## ASSESSMENT REPORT

Local Development Application No: LDA2021/0307

Subject land:	11 Mirool Street West Ryde
Lot and DP Number:	Lot 224 DP 23812
Site Area and dimensions:	Site Area = 682.9m <sup>2</sup>
Proposal:	New dual occupancy (attached) and strata title subdivision.
Applicant:	R.Koncept Architectural Design & Drafting
Owner:	D & M Couwenberg
Date lodged:	7 September 2021
Date clock stopped:	14 October 2021
Date clock started again:	22 December 2021
No. of days on STC:	69 days
Value of Works:	\$977,144.00
Submissions:	Three (3) submissions received objecting to original plans. One (1) submission received objecting to amended plans. Trim Checked on: 22 December 2021
Zoning:	R2 Low Density Residential under RLEP 2014
DCP Non-Compliances:	<ul style="list-style-type: none"><li>• Deep Soil Area.</li><li>• Front Setback.</li></ul>
Clause 4.6 RLEP 2014	No
Councillor Representations	None
<b>Report Recommendation:</b>	Approval

**Figure 3 – Site Plan depicting non-compliant DSA and proposed rear setback (red) and side setback (green).**

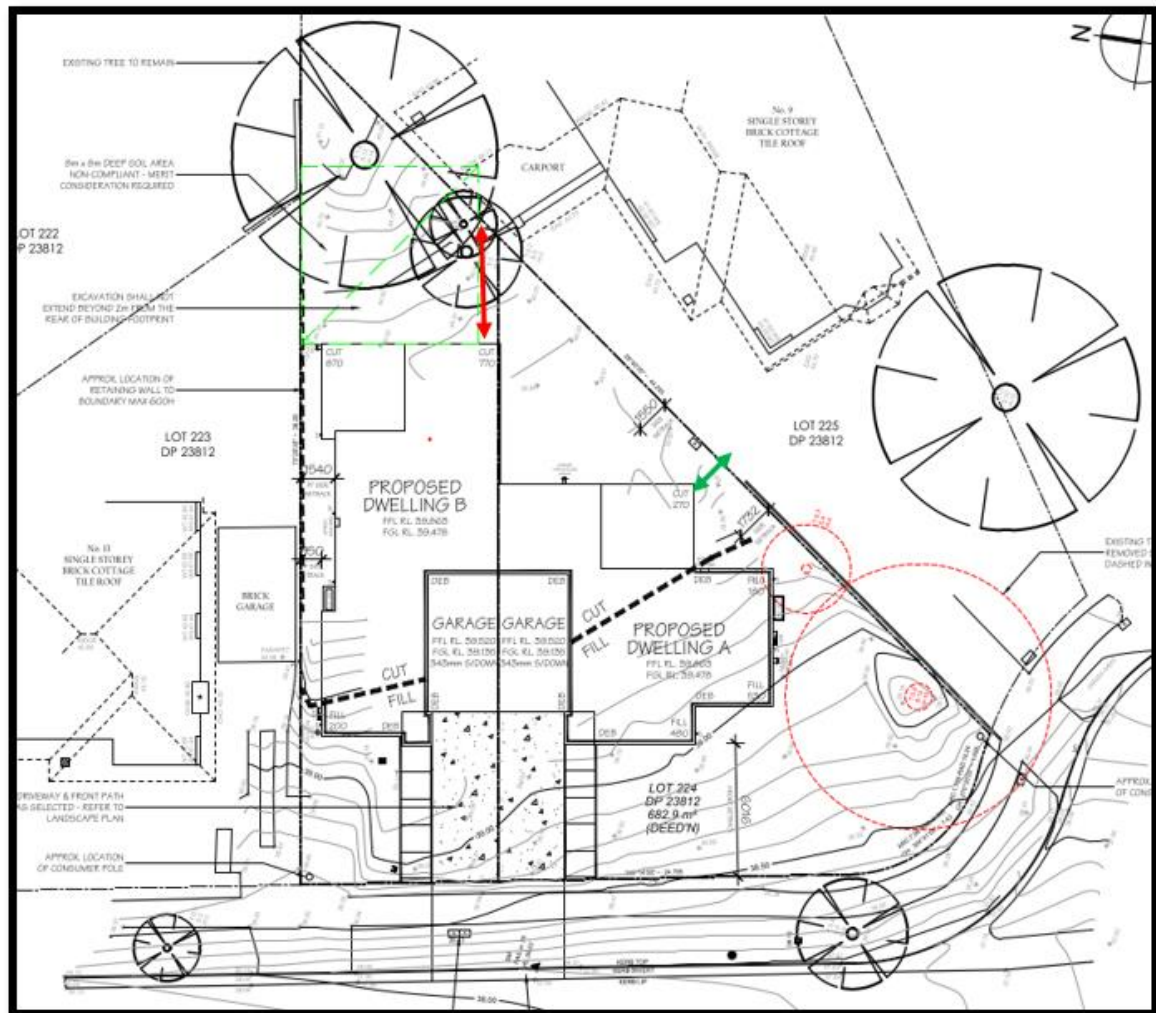
Comment: The proposed dual occupancy will result in two (2) dwellings with neither achieving a full 8m x 8m in the rear yard as indicated by Figure 3 below. However, this non-compliance is considered acceptable for the following reasons:

As such, the proposed 5.06m rear setback as measured from the rear building wall of Dwelling B the shared boundary with No. 9 Mirool Street is non-compliant with the above 8m requirement. However, the non-compliance is considered acceptable for the following reasons:

- A suitable area for private outdoor recreation for both dwellings is provided;
- The portion of non-compliance as indicated in Figure 3 below constitutes the worst point of non-compliance with the rear setback increasing to 12.78m (as measured from the alfresco of Dwelling B);

- There is sufficient area for vegetation and mature trees including the required canopy tree;
- The first-floor portion of Dwelling B that is setback 5.06m is for a voided area. The closest occupants will get from the first floor will be setback approximately 9.2m from the same boundary and therefore the possibility of overlooking to the rear properties is reduced;

**Figure 1 – Proposed development as viewed from Mirool Street.**

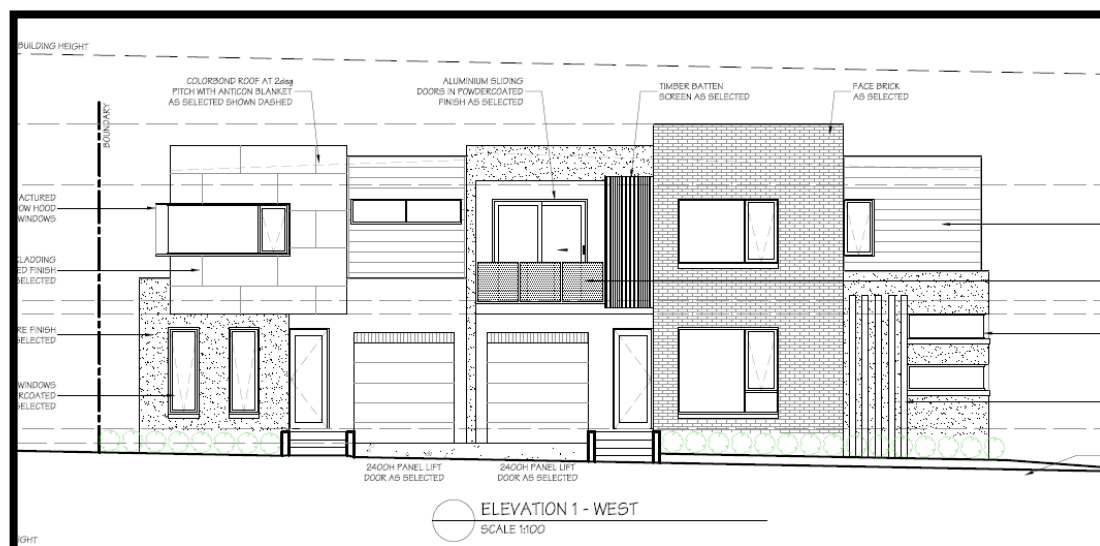
*“While we are not opposed to duplex style developments in general, and understand their advantages, we are becoming concerned with the number of such developments in the street.*

*Mirool St (particularly at our end with its half-moon crescents) is a unique and charming little pocket of West Ryde. It is not a heritage area but has its own charm, and is a friendly neighbourhood. We are concerned that as the number of duplexes increases the character of the streetscape will be lost, and that the already crowded parking situation in the street will only deteriorate.*

Mirool Street is not located within a Heritage Conservation Area or specific character area. In an effort to reduce the bulk and scale of the streetscape and better harmonise the dwelling with the adjoining dwellings, the proposed height of the garage was reduced by 400mm. The overall height of the dwelling is 8.12m which complies with Council’s maximum height of 9.5m and Floor Space Ratio (FSR) is 0.49:1 which is compliant with Council’s 0.50:1 maximum. As such it is considered that effort has been made to lessen the impact to the existing streetscape.

Furthermore, the proposed front setback is 6m which complies with the 6m minimum and each garage is setback 1m to reduce visual impact. The façade of the dwellings will be composed of a mixture of face brick and timber screening with colorbond roofing which will add visual interest to the streetscape in Mirool Street.

**Figure 2 – Proposed building footprint in relation to your dwelling.**

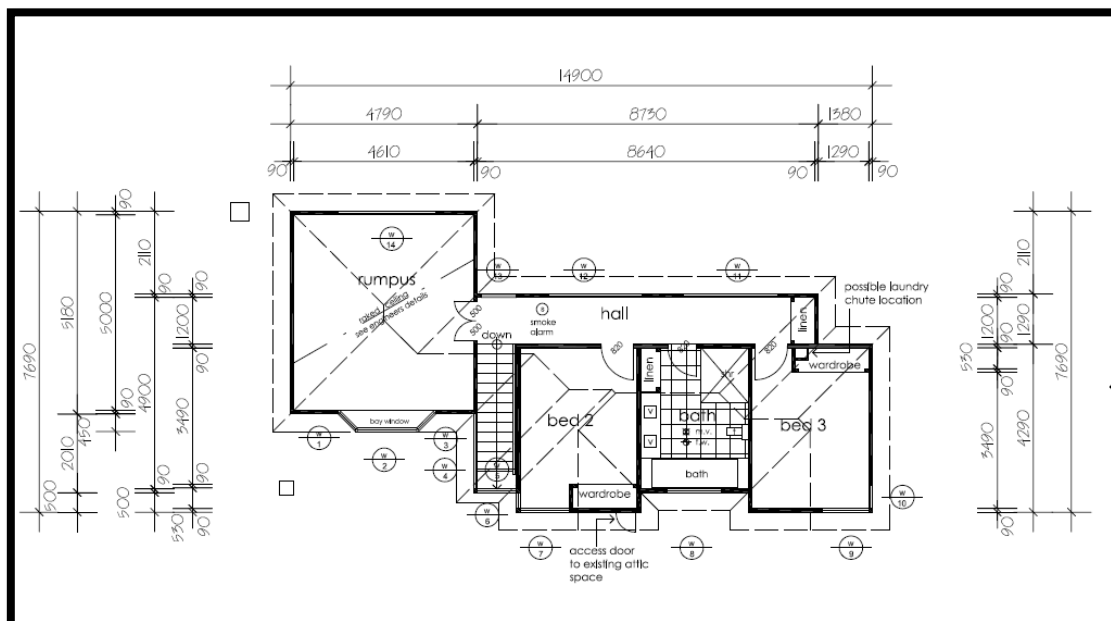
*"We have recently made a second story addition to our own home and in doing so the visual privacy of proposed dwelling (A) may be compromised as windows and doors facing east towards our home will be viewed from a large bay window that sits above our carport. (See elevation 3 - EAST). We fear that perhaps the design of the dwelling has not taken this new extension into account and should be reviewed."*

Due to the positioning of the site, the windows of Dwelling A as shown on the South elevation will overlook your front yard and will not pose views into any living room areas or rear private open space. The South-facing elevation of Dwelling B has no windows and will not overlook your private open space, with a small alfresco at ground level orientated away from your dwelling. As such, the proposal complies with the visually privacy controls within the Ryde DCP 2014, and it is considered that there will be minimal overlooking to your private open space or living room windows and the proposal is considered acceptable.

Figure 2 – Proposed Landscape Plan.

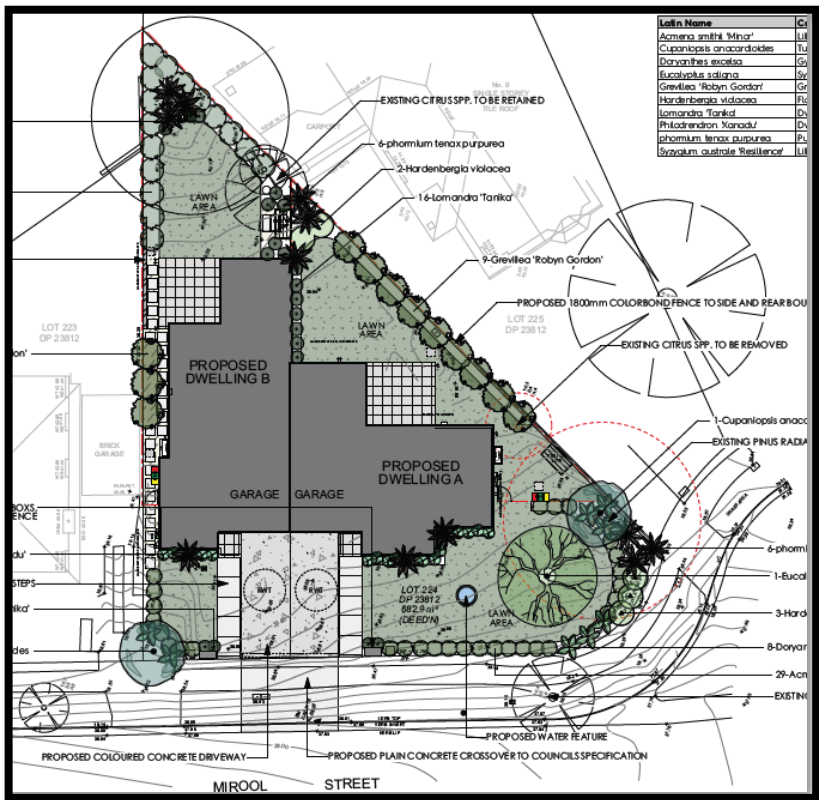
*“Finally, we understand that although fencing is not part of the DA proposal, we would prefer a timber paling fence between our own home and any new development at number 11, as is already suggested in the landscaping document.”*

Comment: The Landscape plan notes a ‘1.8m high colorbond fence to side and rear boundaries’. Council raises no objection to the proposed colorbond fencing or any negotiated timber fencing to a height of 1.8m. All neighbourly negotiations on dividing fences are to be conducted as per the *Dividing Fences Act 1991*.
